UNITED STATES PATENT AND TRADEMARK OFFICE

APPLICATION NO.	FILING DATE	FIRST NAMED INVENTOR	ATTORNEY DOCKET NO.	CONFIRMATION NO.
09/684,658	10/10/2000	Hugh G. Loebner		4106

<b>Office Action Summary</b>	Application No.	Applicant(s)
	09/684,658	LOEBNER, HUGH G.
	Examiner Ernesto Garcia	Art Unit 3679

FIG. 4

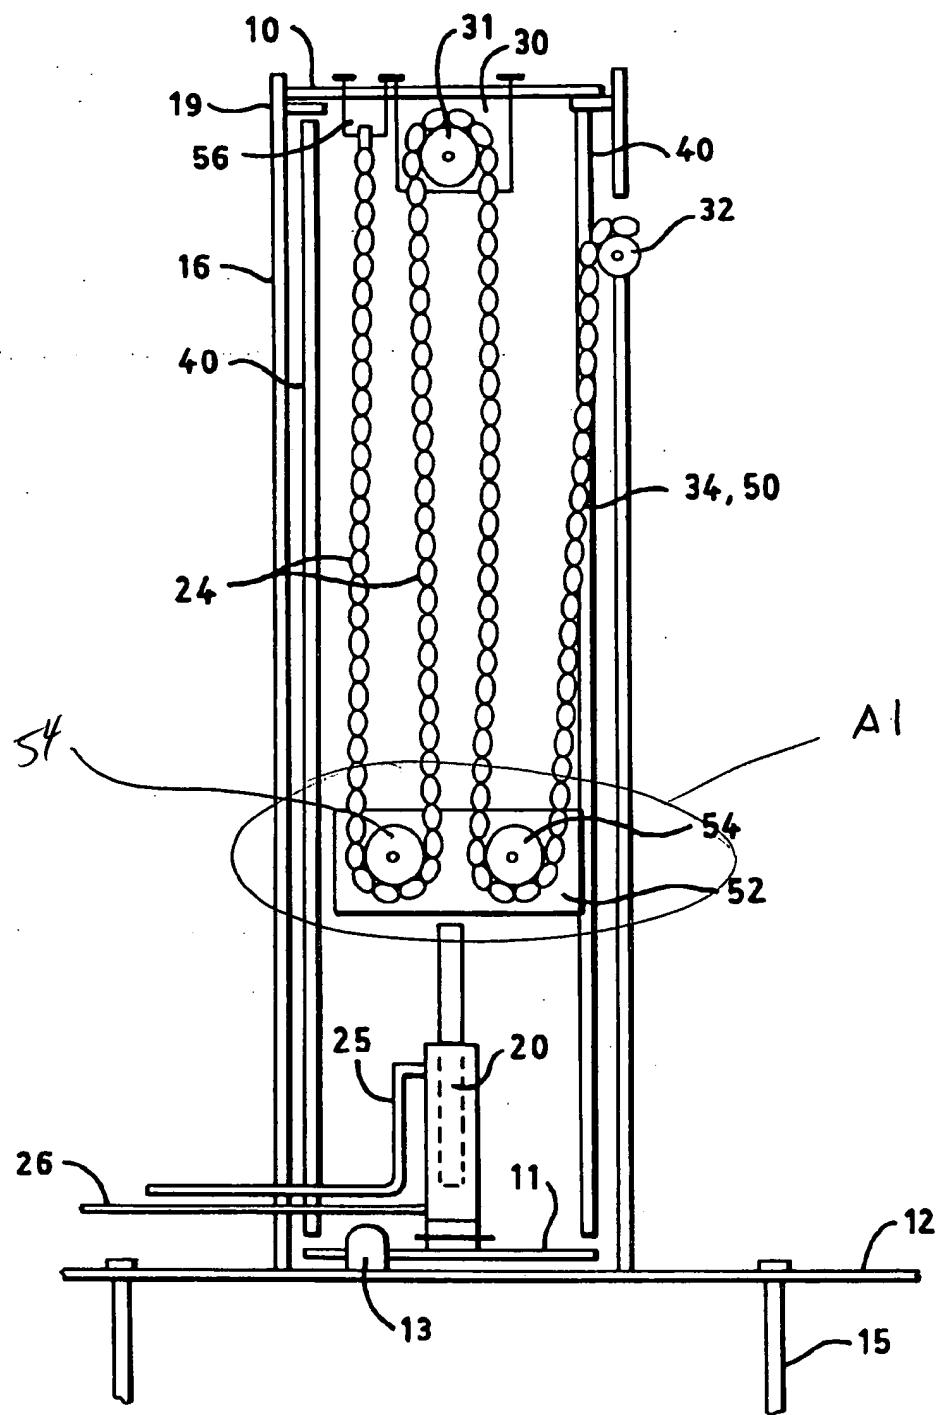
Gompertz et al. (See attachment) teaches in Figure 4 a bottom block assembly **A1** comprising rollers **54** to quadruple a length of tape **34, 50** per distance that is released (col. 5, line 64 - col. 6, line 5) from the post. Therefore, as taught by Gompertz et al., it would have been obvious to one of ordinary skill in the art at the time the invention was made to comprise the bottom block assembly of more than one roller to quadruple the length a tape that is released from a post.
